UNITED STATES PATENT AND TRADEMARK OFFICE

APPLICATION NO.	FILING DATE	FIRST NAMED INVENTOR	ATTORNEY DOCKET NO.	CONFIRMATION NO.
10/780,240	02/17/2004	Malcolm I. Falconer	C-314 DIV	9660
26079	7590	06/24/2005	EXAMINER	
BRISTOL-MYERS SQUIBB COMPANY 100 HEADQUARTERS PARK DRIVE SKILLMAN, NJ 08558			BOGART, MICHAEL G	
			ART UNIT	PAPER NUMBER
			3761

Office Action Summary	Application No.	Applicant(s)	
	10/780,240	FALCONER, MALCOLM I.	
	Examiner	Art Unit	
	Michael G. Bogart	3761

DETAILED ACTION

FIG. 1

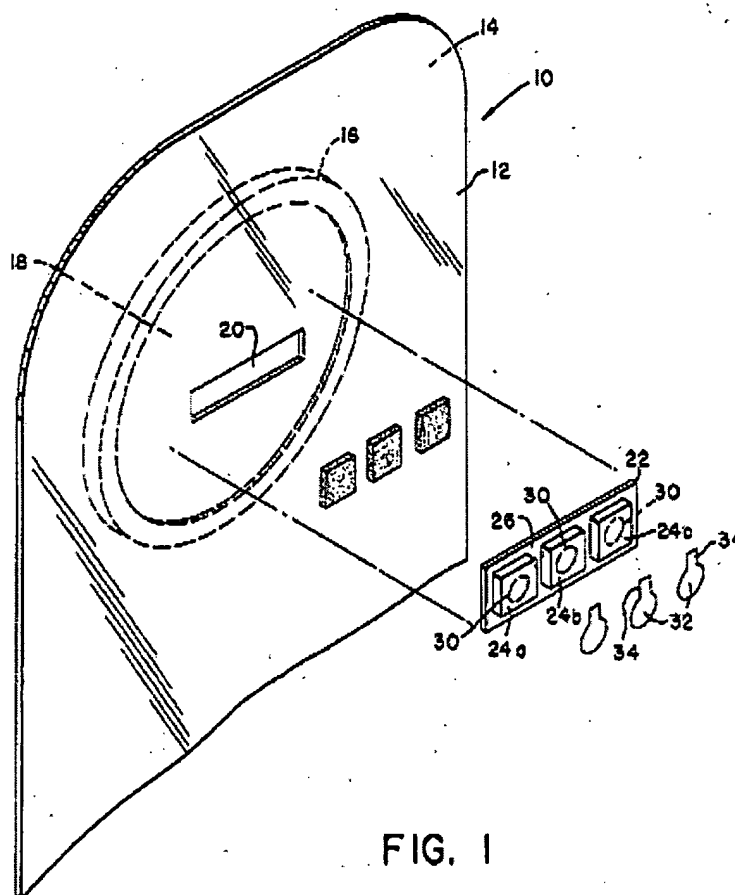
Regarding claim 1, Leise, Jr. teaches an apparatus comprising a controllable flow rate, filtered vent (20) for an ostomy pouch (10), the vent (20) having a plurality of outlets (30) and a device (24, 30) for controlling the rate of flow of gas through the vent (30), the device (24, 30) comprising adhesive sticker means (32) which can be positioned and, re-positioned (32) to selectively expose or cover one or more of the plurality of outlets (30), and thereby regulate variably the rate of flow of gas according to the outlets (30) exposed (figure 1).

Regarding claim 2, Leise, Jr. teaches that the flow rate is controllable according to the number of outlets (30) exposed.

Regarding claim 3, Leise, Jr. teaches a three part sticker means (32) that is of sufficient size to cover all of the outlets (30).

Regarding claim 4, Leise, Jr. teaches that one or more of the outlets (30) comprises a hole (30) in a layer (22, 24) to which the sticker means is adherable.

Regarding claim 5, Leise, Jr. teaches that one or more of the outlets (30) comprises a clearance (26) between one or more outlets (30).

Regarding claim 6, Leise, Jr. teaches a filter comprising a flow restricting layer (28) provided upstream of the outlets (30).

Regarding claim 7, Leise, Jr. teaches that the vent (20) means having a plurality of apertures (30) for outletting gas through said vent (20), and a flow restricting layer (28) upstream of the aperture means (30).

Regarding claims 8 and 9, Leise, Jr. teaches that the aperture means (30) comprises a plurality of individual apertures (30)(figure 1).

Regarding claim 10, Leise, Jr. teaches that the sticker means (32) is positioned or positionable to selectively block all of the area of the aperture means (30) by using all three sticker means subcomponents.

Regarding claim 11, Leise, Jr. teaches that the flow restricting layer (28) comprises microporous material.

Regarding claim 12, Leise, Jr. teaches that the pouch (10) comprises a first wall (12) provided with the vent (20) and with a comfort layer (22).
